NAME & DESCRIPTION OF PROPOSAL: Cordova Building Stream Sediment Maintenance

FILE NUMBER: 09-113567-LO

**City of Bellevue
Development Services Department
Land Use Staff Report**

**REVISED STREAMBED SEDIMENT
MAINTENANCE PLAN**
Cordova Building
Bellevue, Washington

Figure 3

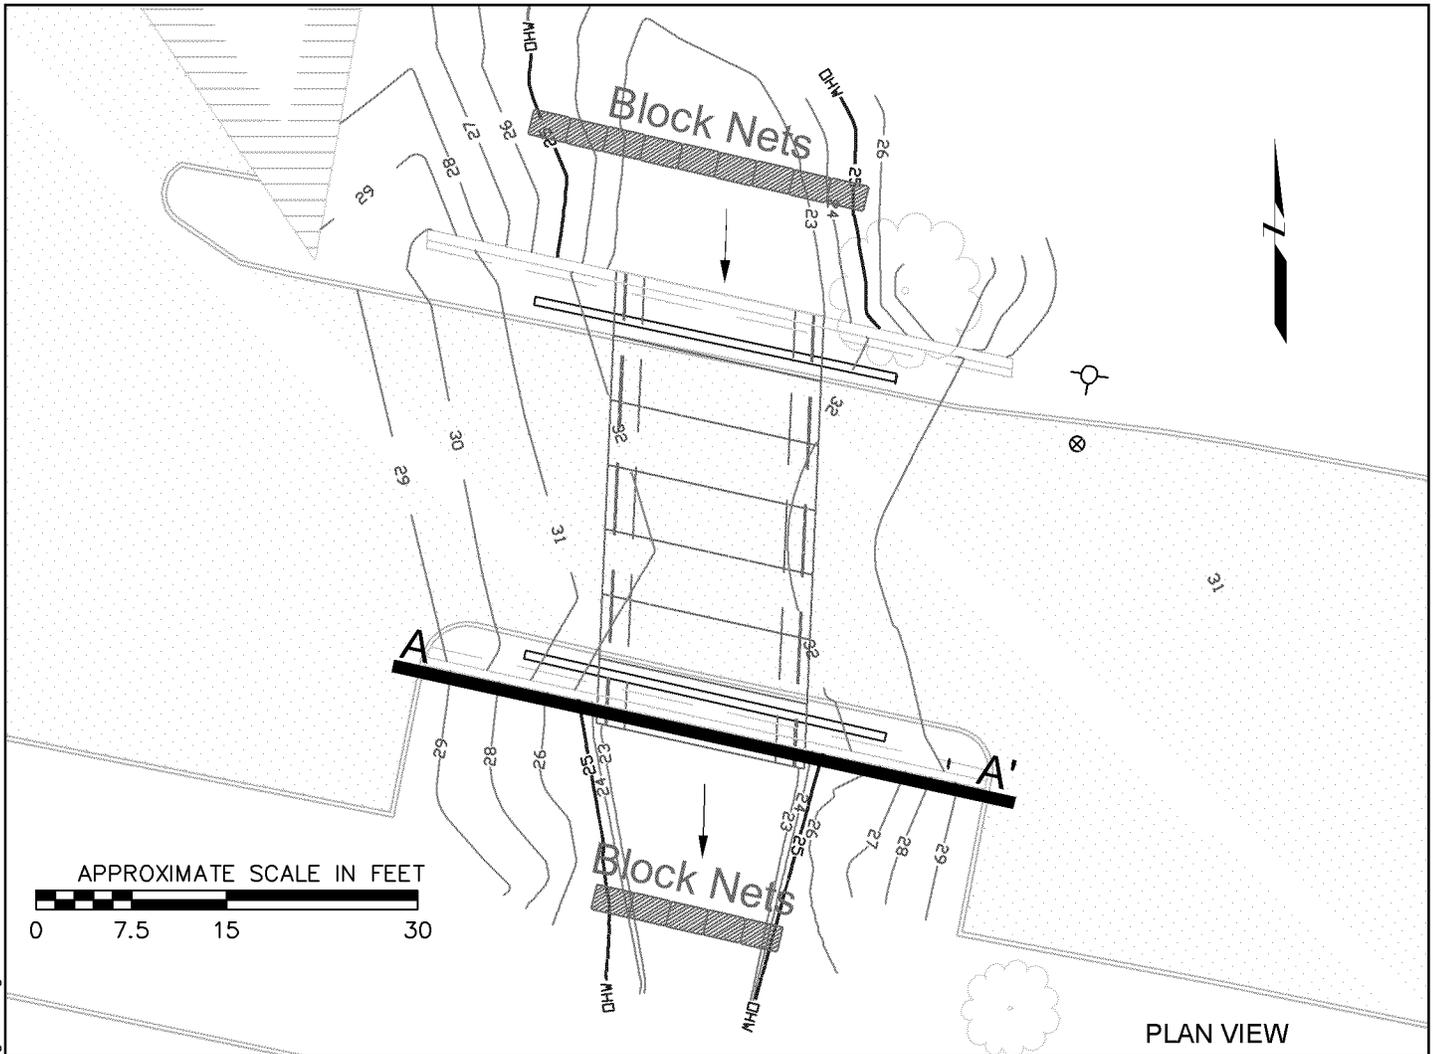
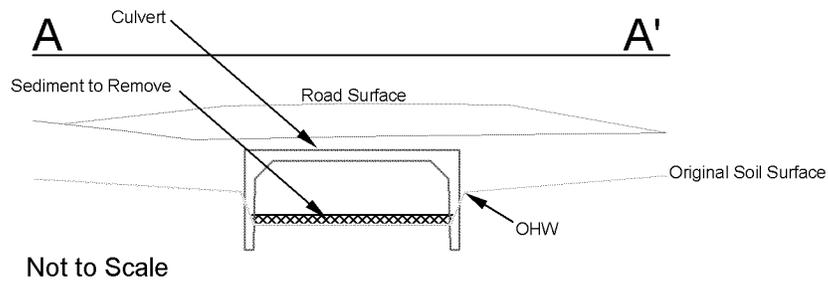
To determine susceptibility of the site to continued deposition, basic surveying of channel geometry was conducted. A longitudinal profile and three cross sections were surveyed using a surveyor's level, stadia rod, and surveyor's tape. The longitudinal profile indicates that the channel slope is greater downstream from the lower culvert than upstream (0.4% vs. 0.1%). The cross sections also indicate that the width-to-depth ratio is greater downstream of the culvert than it is upstream. These two components of channel geometry suggest that deposition will tend to occur at the site. When there is a decrease in stream power, such as at an expansion of the channel, deposition can be expected. The increase in width-to-depth ratio at the culverts represents such an expansion. The lower channel slope at the two culverts also indicates that stream power is lower at this site than above or below, increasing the propensity for deposition. Sediment removal in the vicinity of the culvert will need to occur periodically over the life of the culvert or until measures are taken upstream of the culvert to reduce sediment input into Sturtevant Creek.

To maintain the culvert's capacity to allow the 100-year floodwater to pass through the culvert without flooding the property, sediment removal in the vicinity of the culvert will need to occur periodically. To remove sediment from the streambed, the following permits will need to be obtained (Figure 3):
